**08/04/2016 Staff feedback on RAI 208-8245; Q 03.08.03-1**

Figure 1. The Scaling Factor with Different Initial Pool Temperature

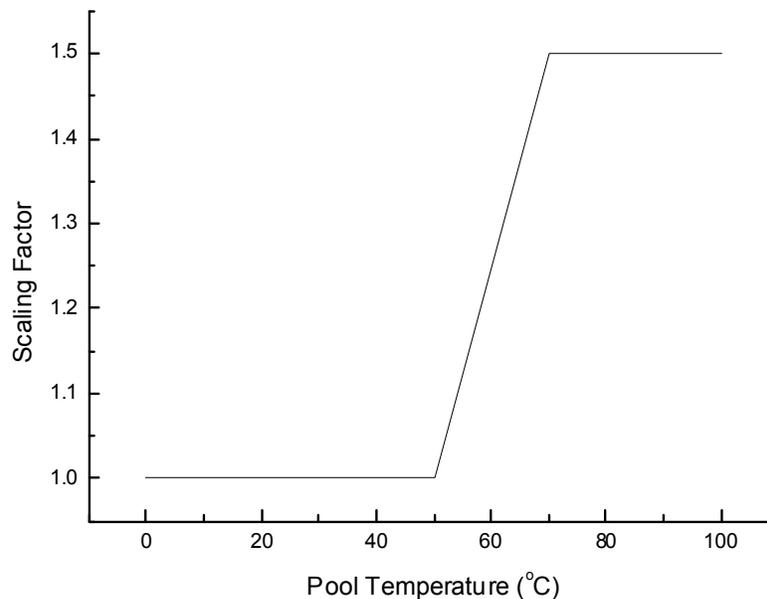
- 1) background for the scaling factors for part (a) (see below), specifically, n-sub-g, n-sub-z, and n-sub-v.
- 2) We also need to confirm that the equation on page 5/9 refers to  $r > 2r_0$  rather than just "0" (We have the background info that corroborates this, so this should just be a simple confirmation of a typo).

The Studsvik tests have indicated that the maximum pressure amplitudes are increasing noticeably with increasing pool water temperature above a level of about 50-60 °C. The scaling factor to account for differences in initial pool water temperatures is shown in the Figure 1. The maximum initial IRWST temperature is 120 °F (48.9 °C). Therefore, the scaling factor to account for differences in the pool water temperature,  $\eta_T$  is 1.0.
